Application No: DA-950/2025/A
Date: 21/7/26

SECTION 4.55 PACKAGE

DEMOLITION OF EXISTING DWELLING AND CONSTRUCTION OF NEW DOUBLE STOREY SEMI - ATTACHED DUAL OCCUPANCY

35 DENNIS STREET LAKEMBA 2195 NSW

DRAWING TITLE
SIDE ELEVATIONS - UNIT 2

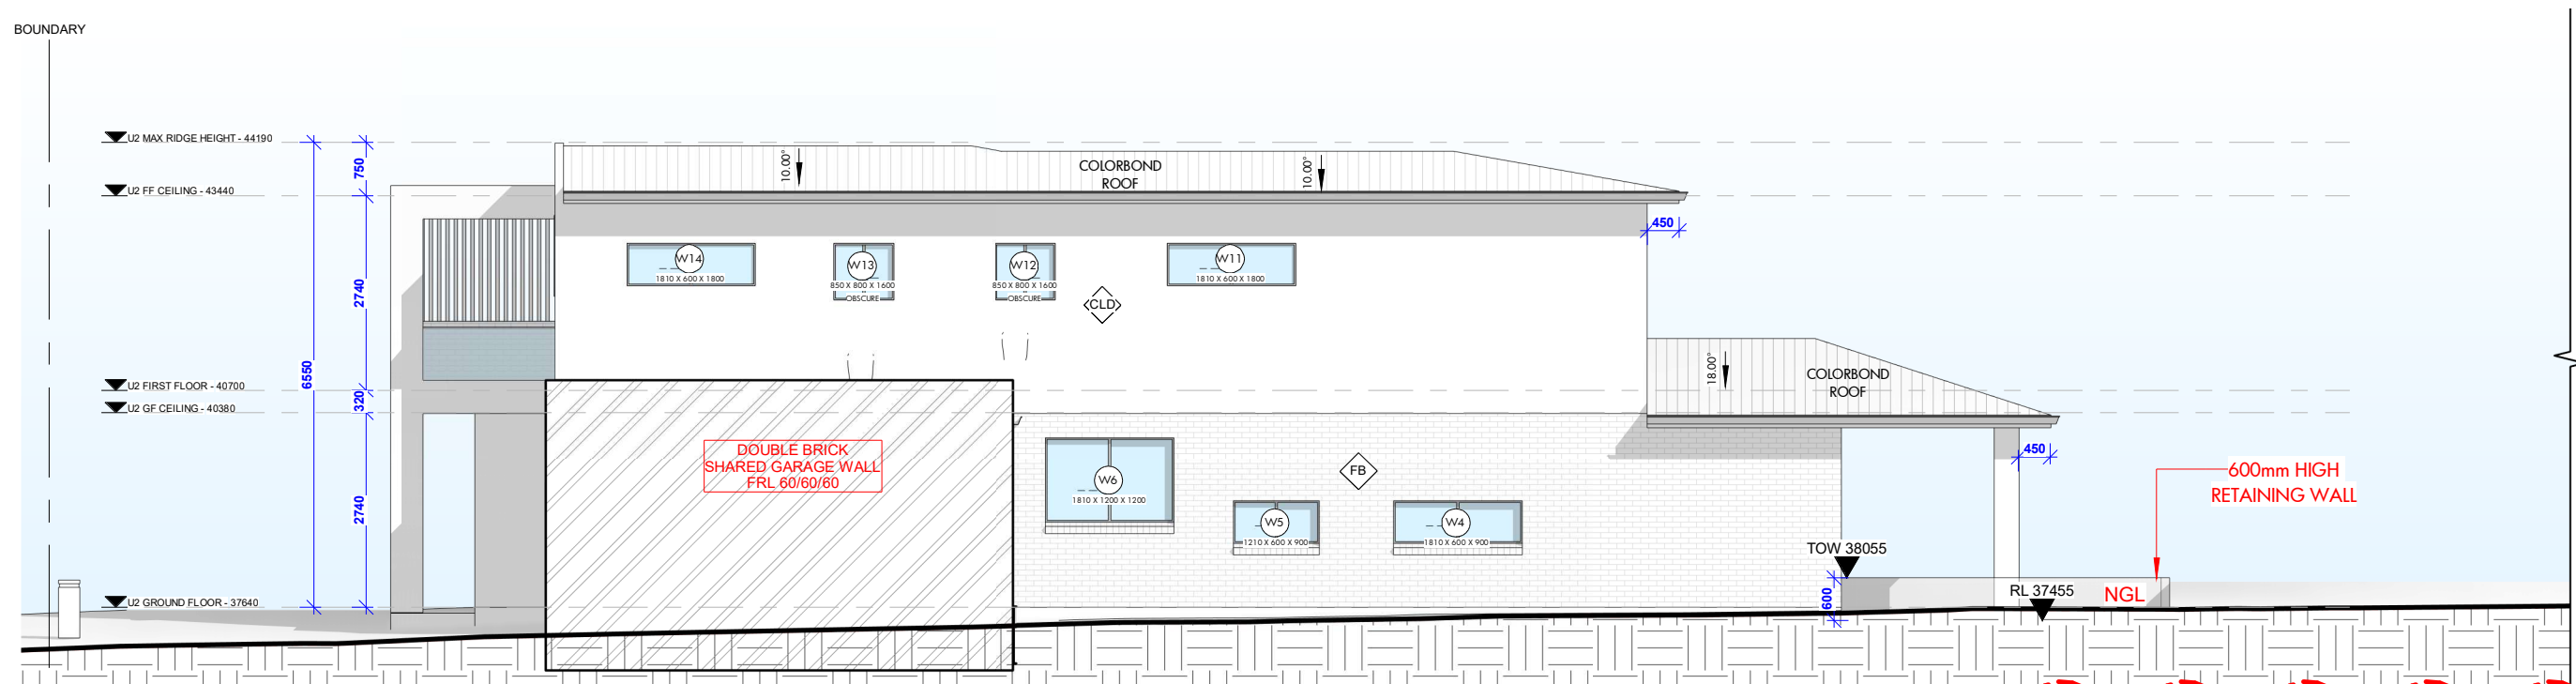
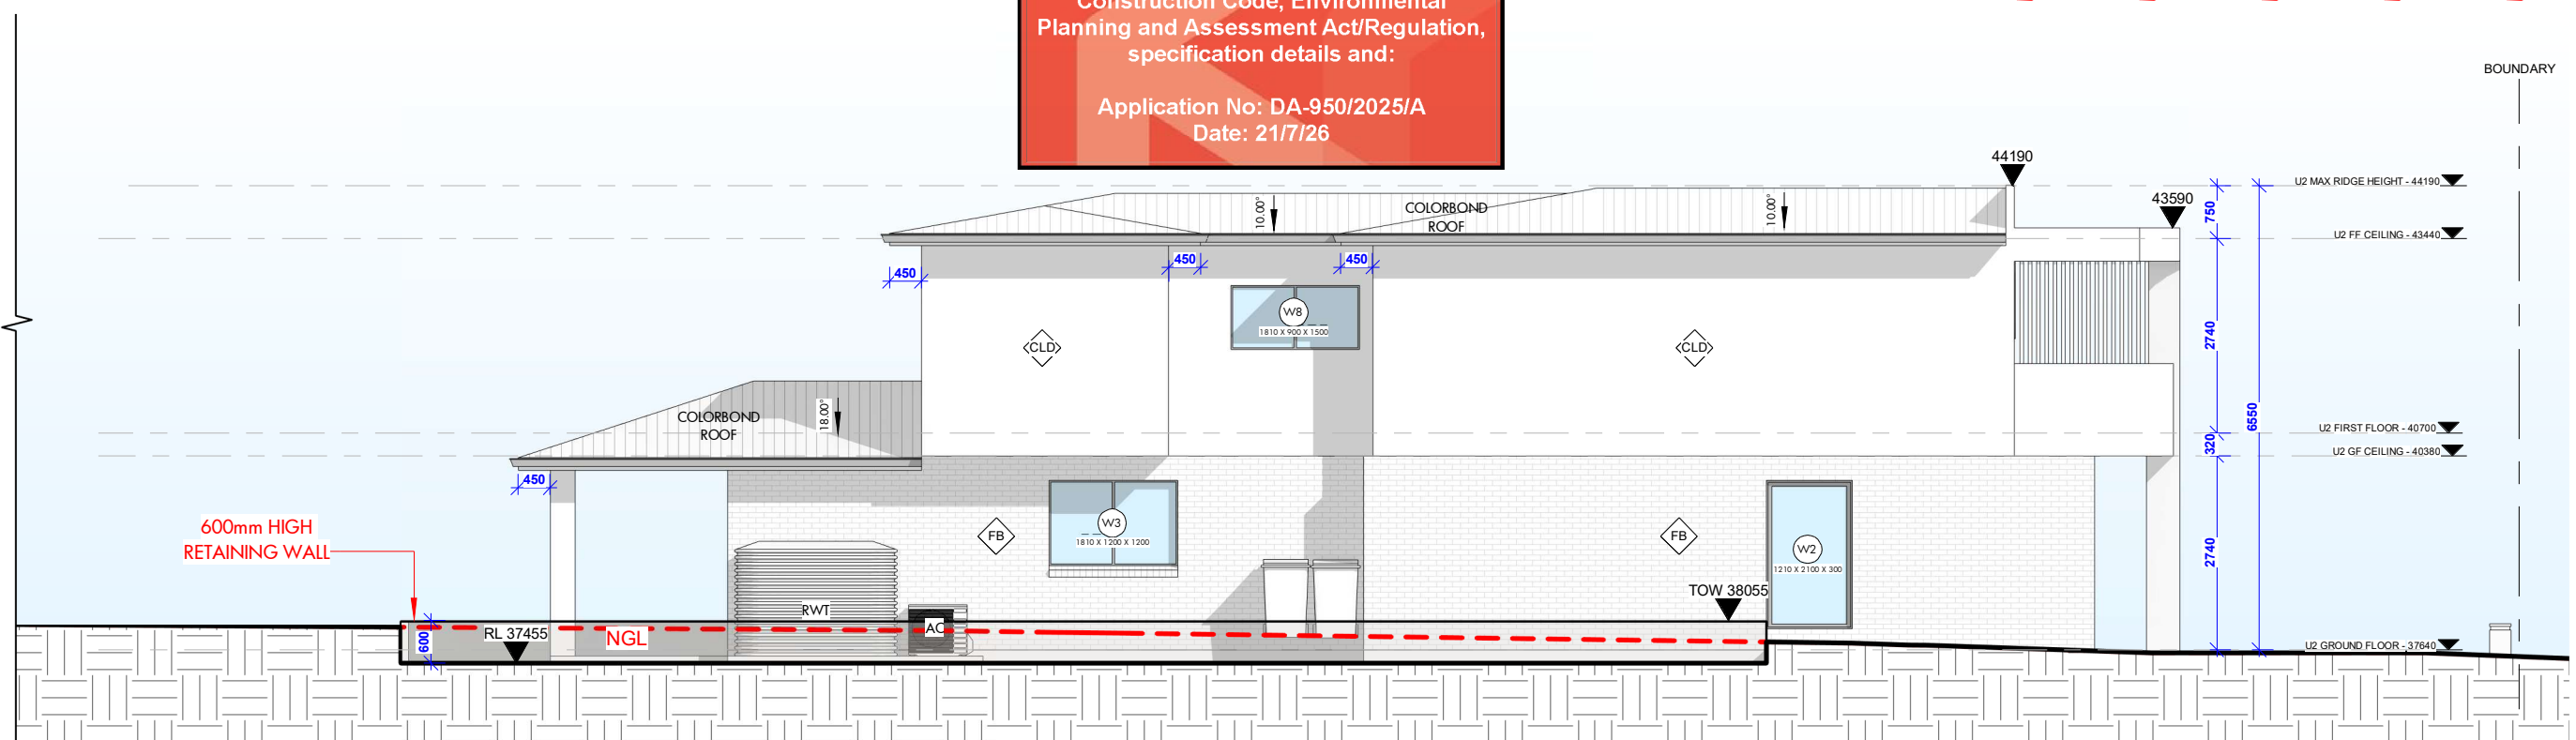
NOTE: SUBDIVISION WALL BETWEEN THE TWO HOUSES MOVED ACCEDENTLY.
NOW CORRECTED IN SECTION 4.55 APPLICATION. NO OTHER CHANGE PROPOSED.

DRAWING TITLE
FRONT AND REAR ELEVATIONS

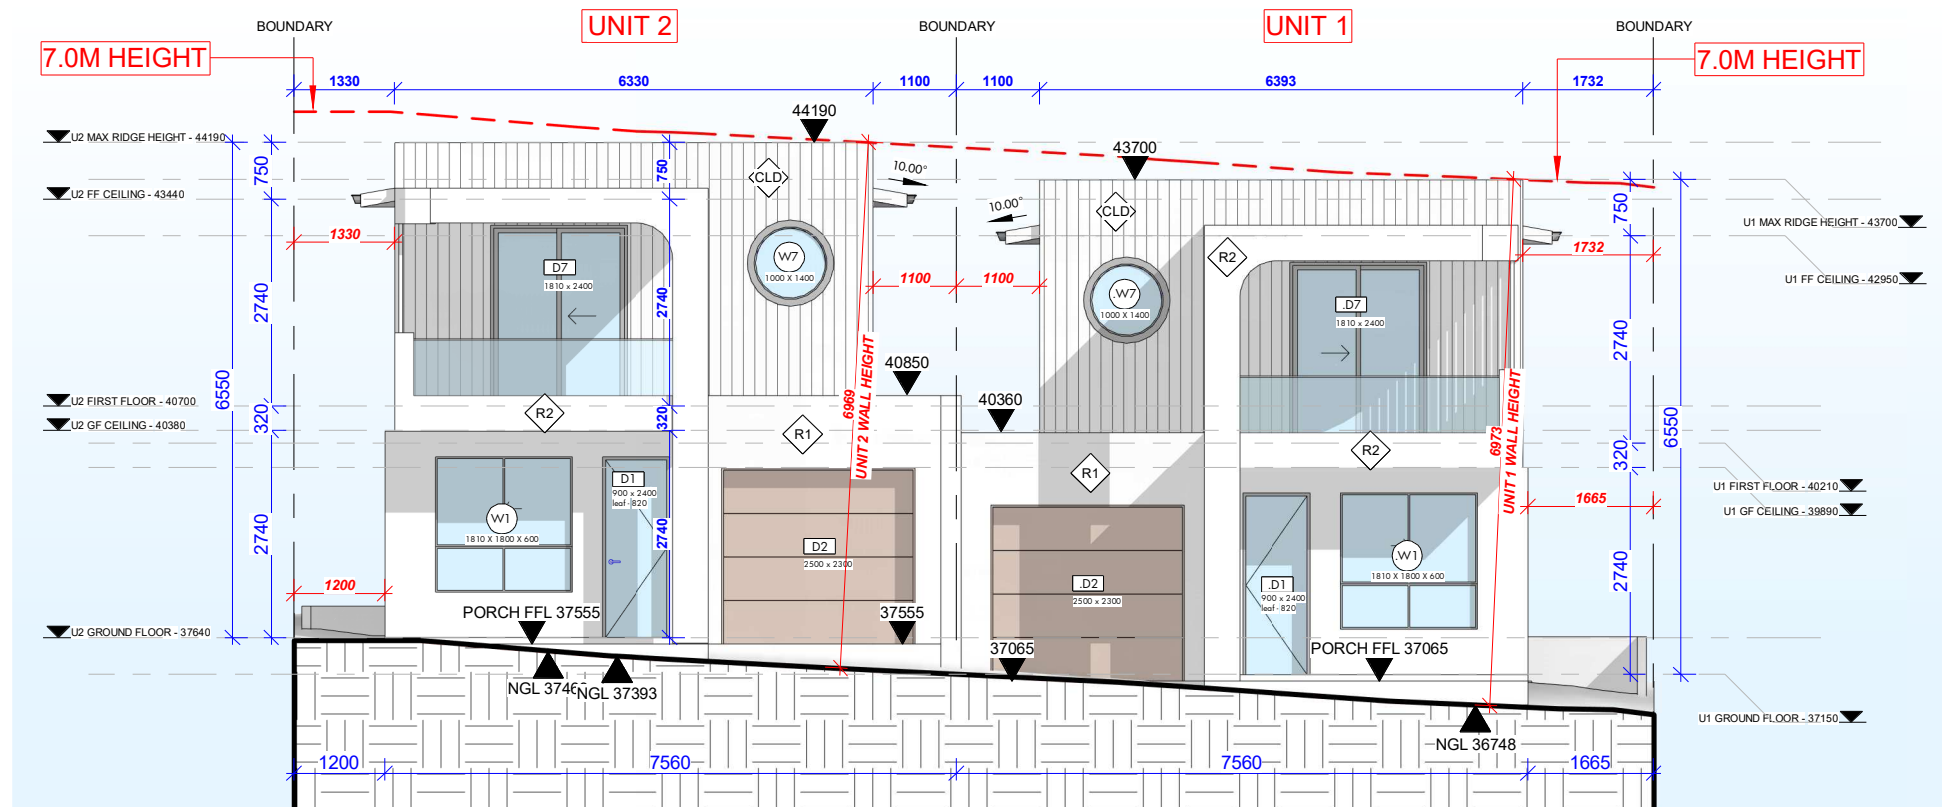
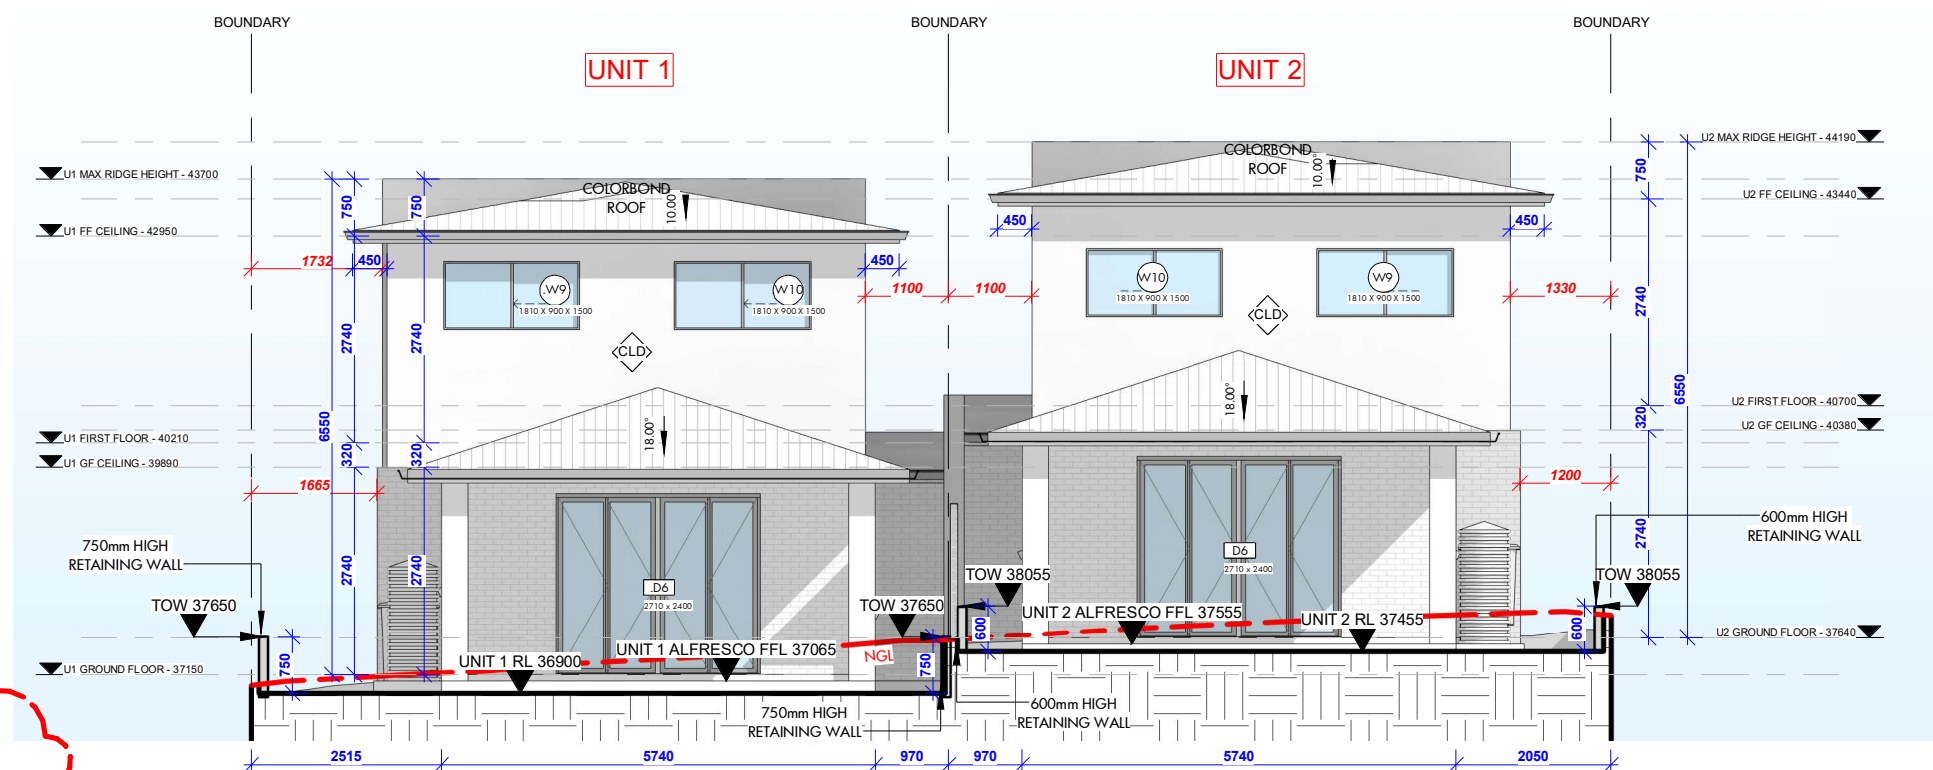
NOTE: SUBDIVISION WALL BETWEEN THE TWO HOUSES MOVED ACCIDENTLY.
NOW CORRECTED IN SECTION 4.55 APPLICATION. NO OTHER CHANGE PROPOSED.

DRAWING TITLE
LONG SECTIONS

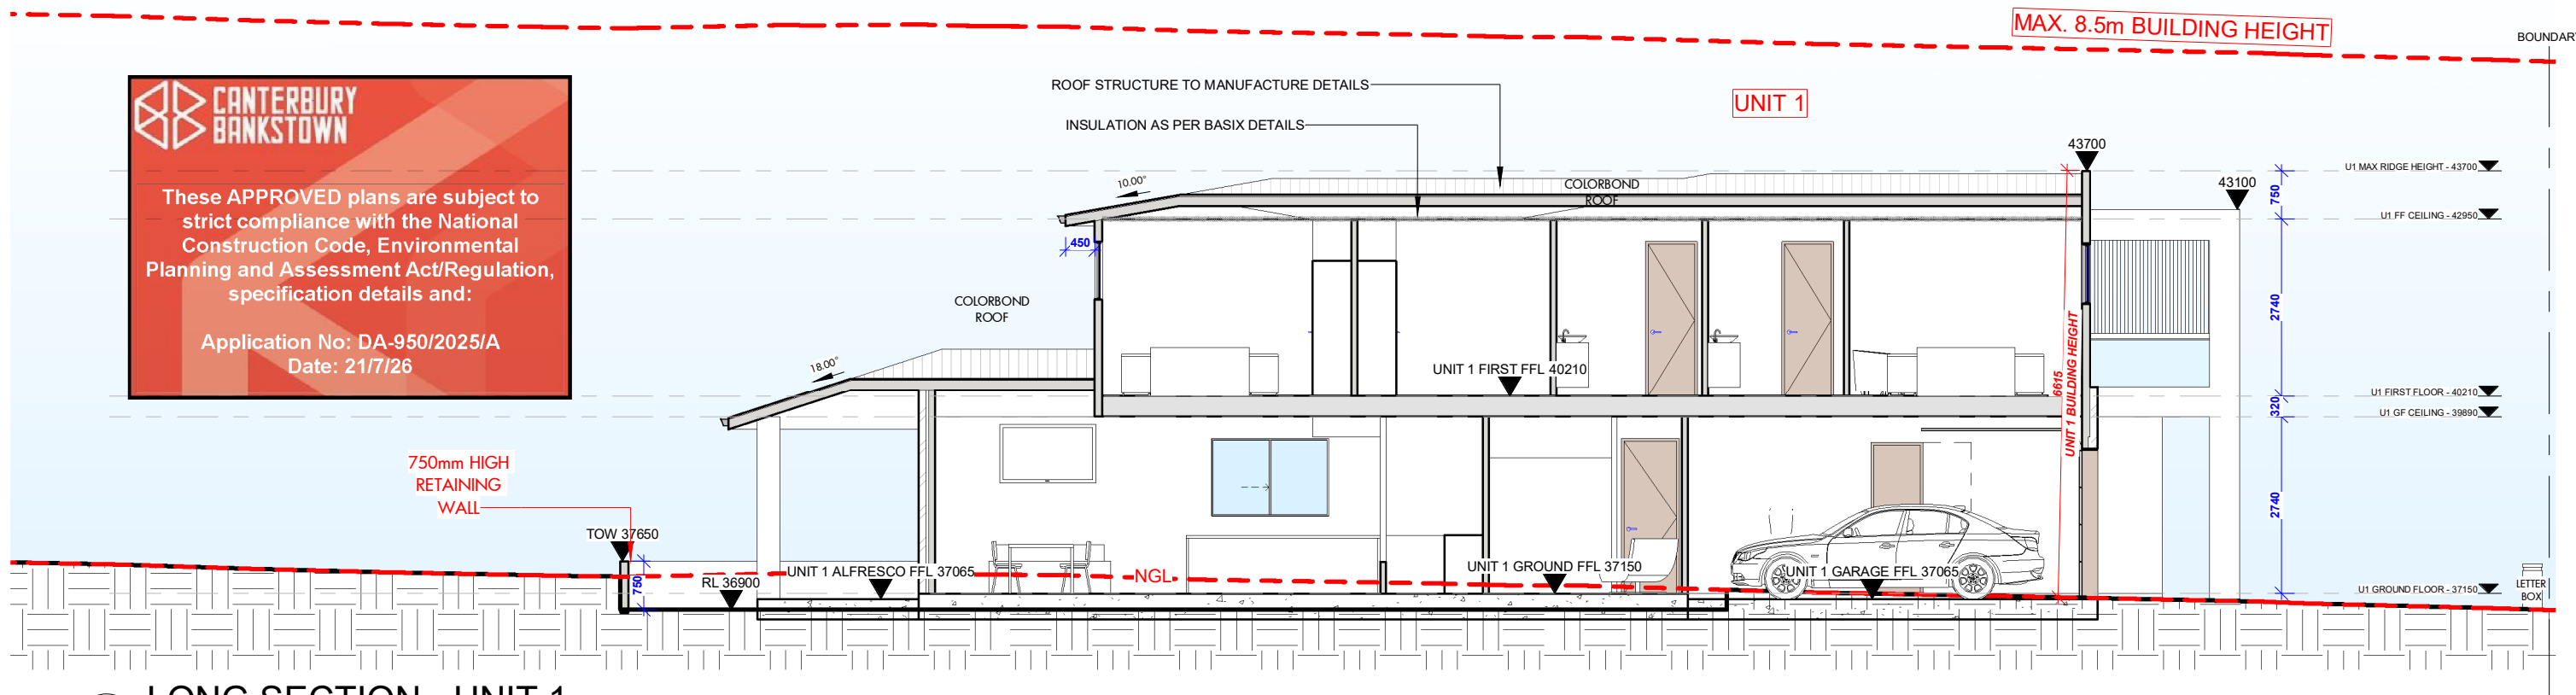
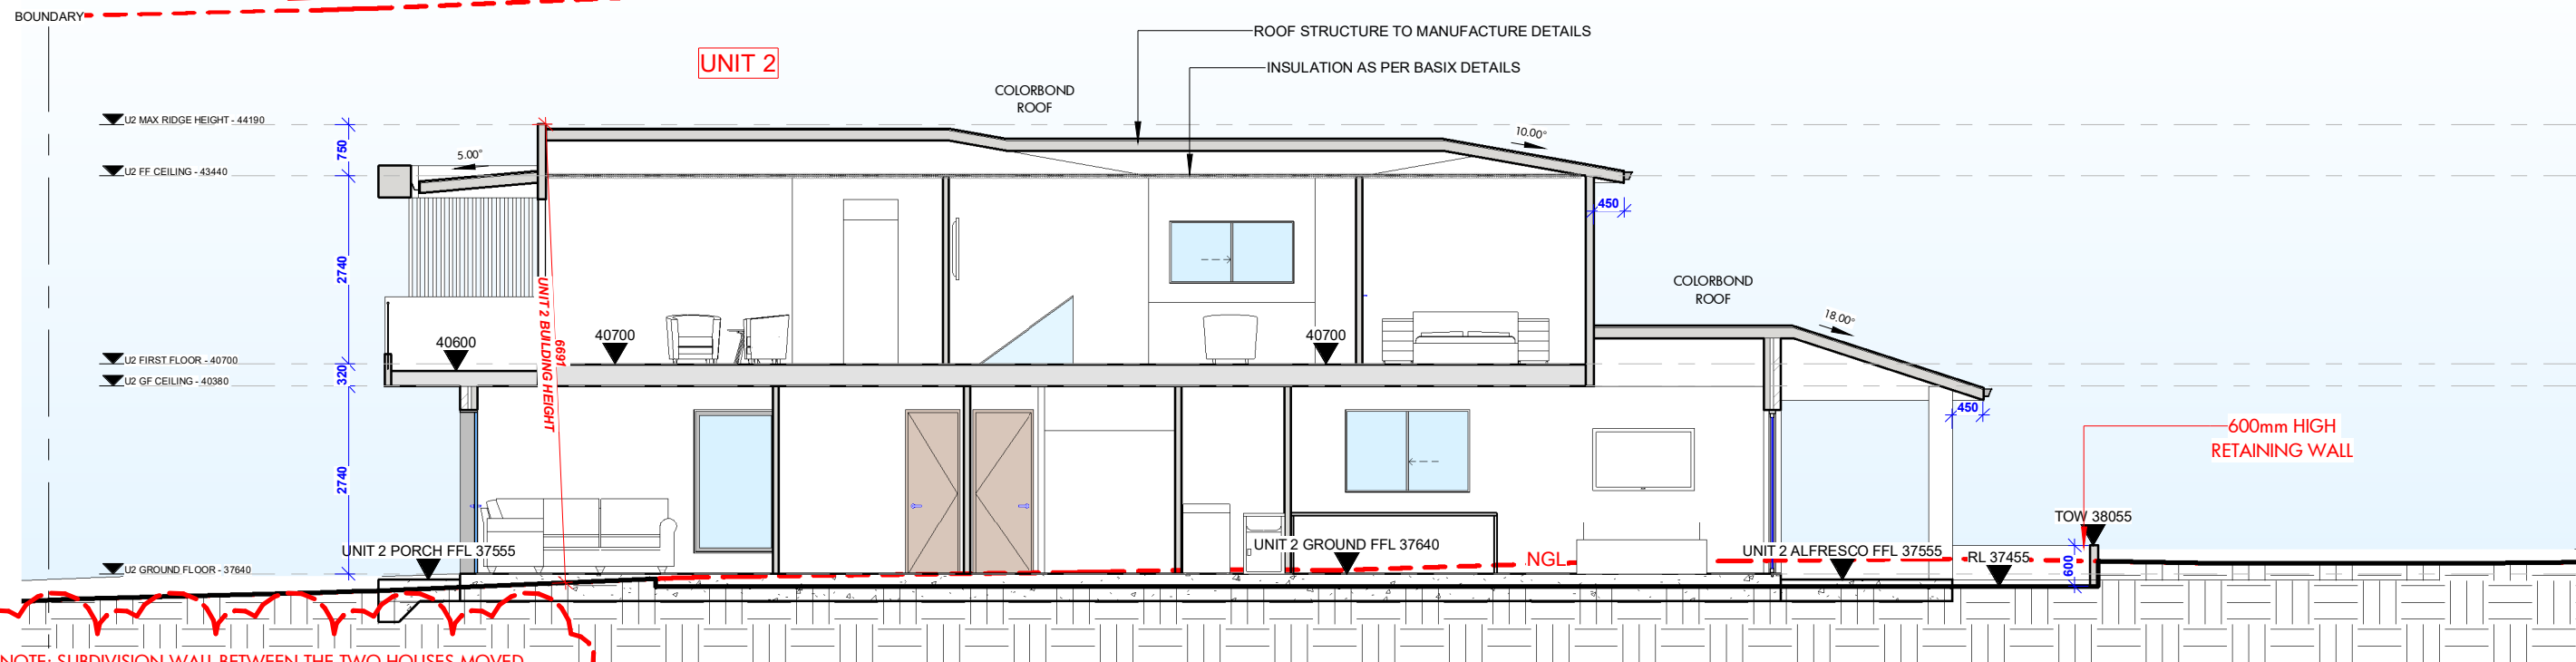
NOTE: SUBDIVISION WALL BETWEEN THE TWO HOUSES MOVED ACCIDENTLY.
NOW CORRECTED IN SECTION 4.55 APPLICATION. NO OTHER CHANGE PROPOSED.
